SYSTEM DESCRIPTION, INSTALLATION,  
AND MAINTENANCE MANUAL  
MCS-4000/7000

## TEMPORARY REVISION NO. 23-2

TO HOLDERS OF MCS-4000/7000 MULTI-CHANNEL SATCOM SYSTEM SYSTEM DESCRIPTION,  
INSTALLATION, AND MAINTENANCE MANUAL 23-20-27, REVISION 2, DATED 5 FEB 2008.

## TEMPORARY REVISION NO. 23-1

**Figure 4-2. Satellite Data Unit Outline and Installation Diagram**

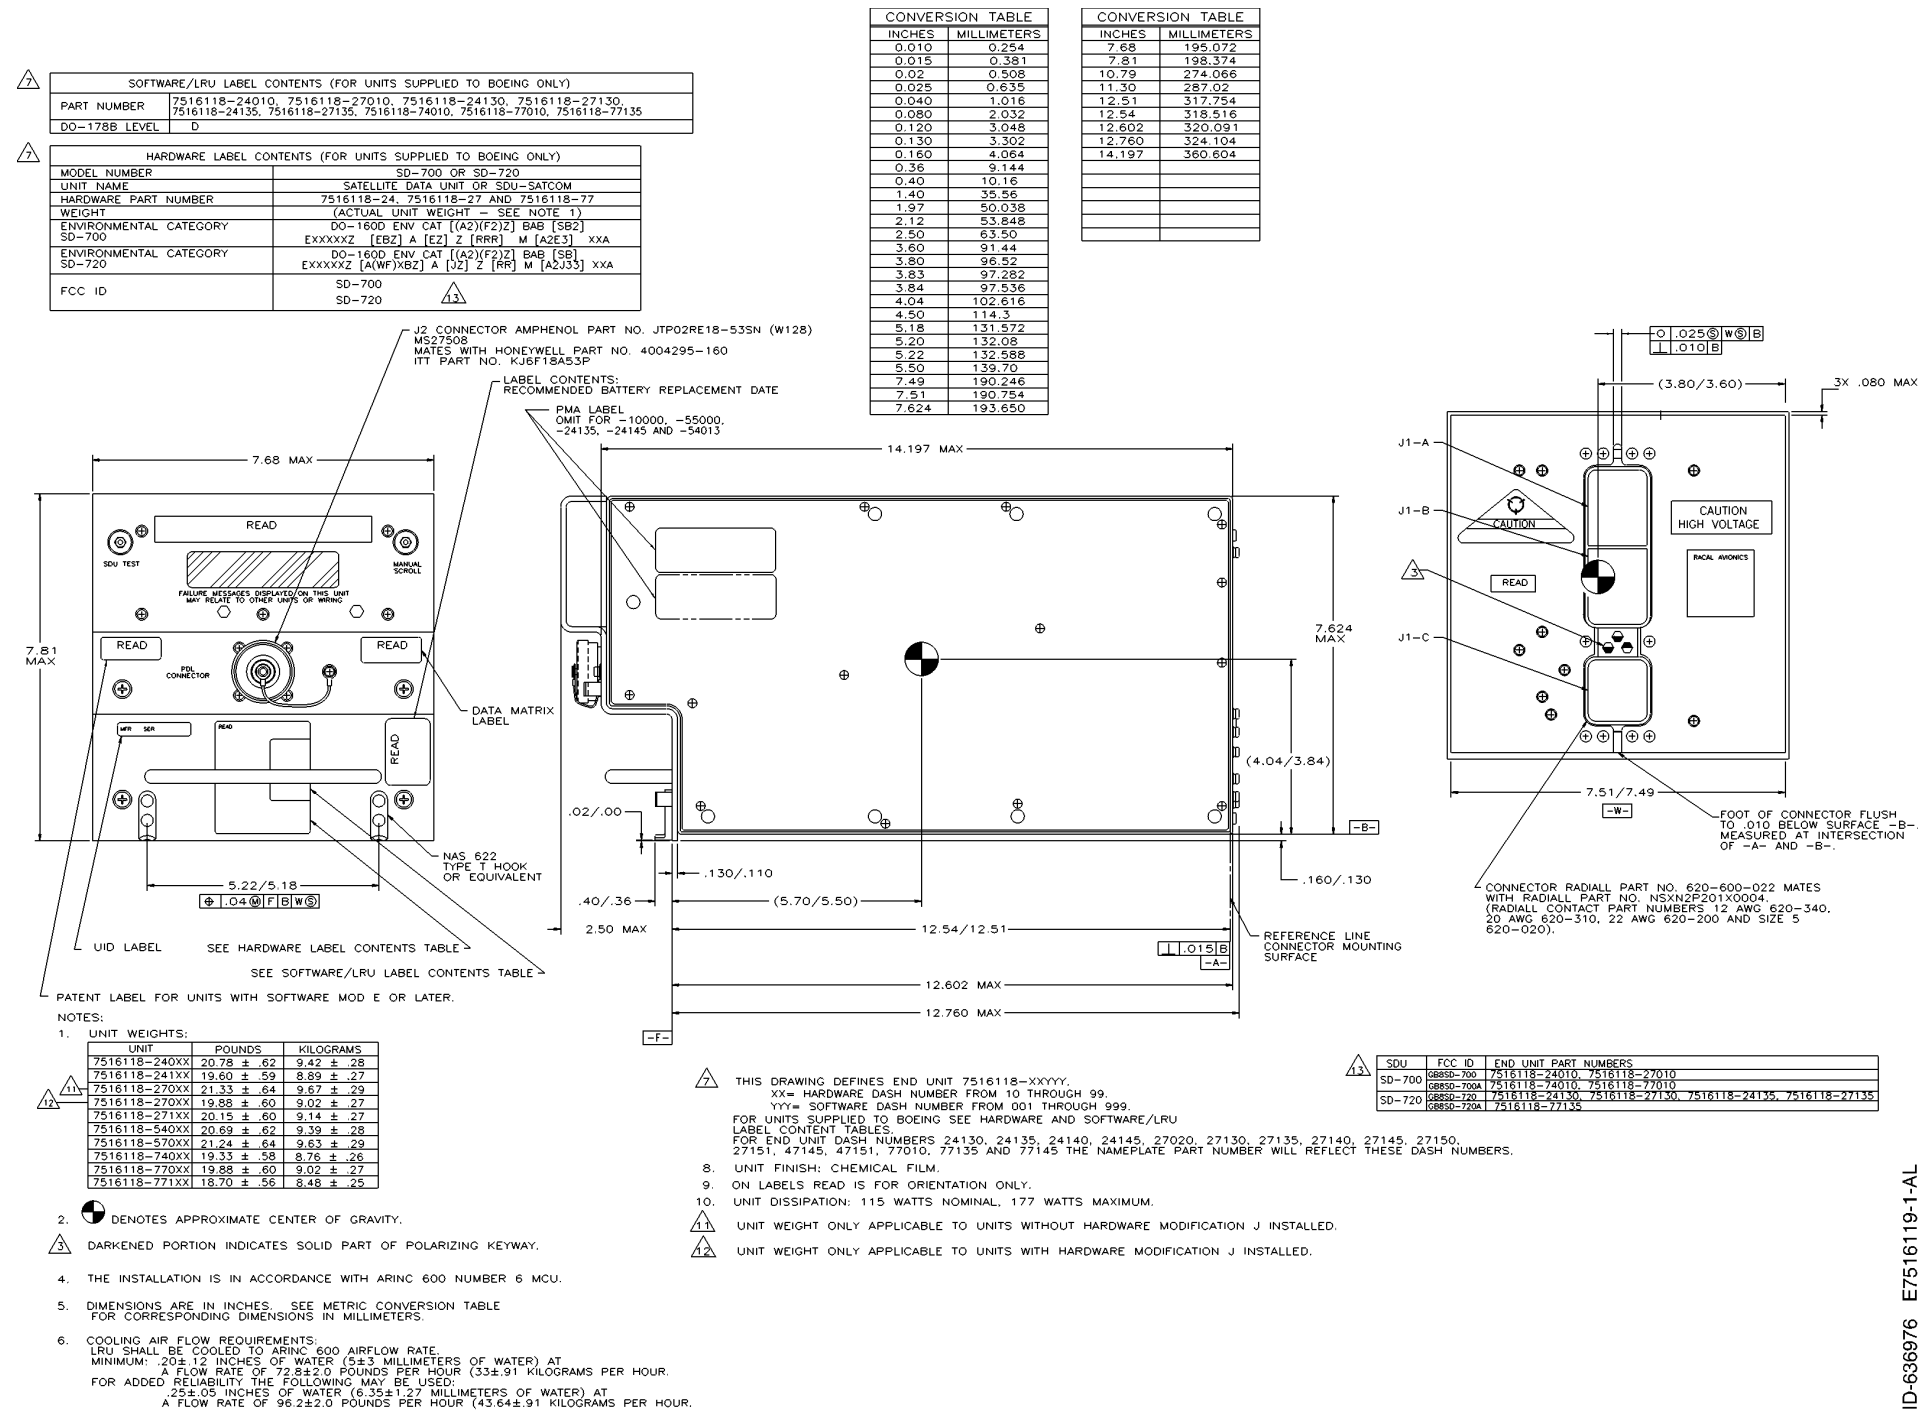
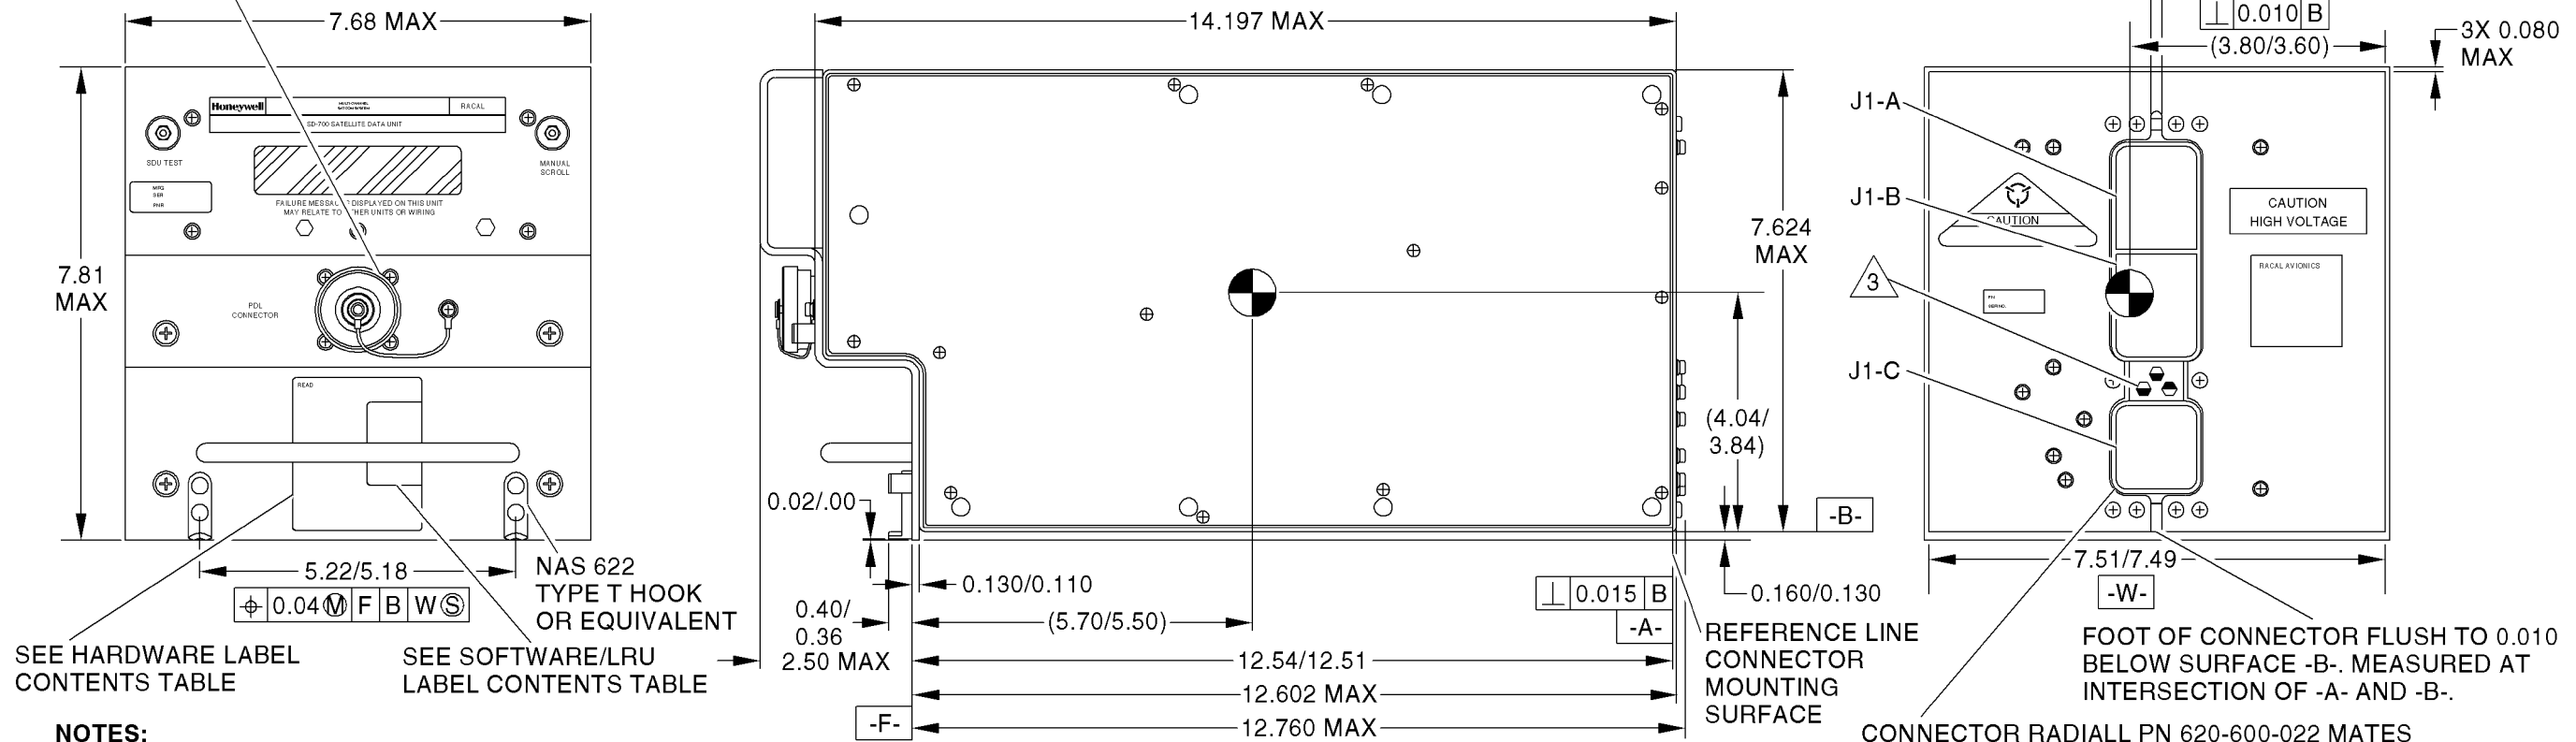
Reason: To change drawing data for Figure 4-2.

Figure 4-2 is changed as follows:
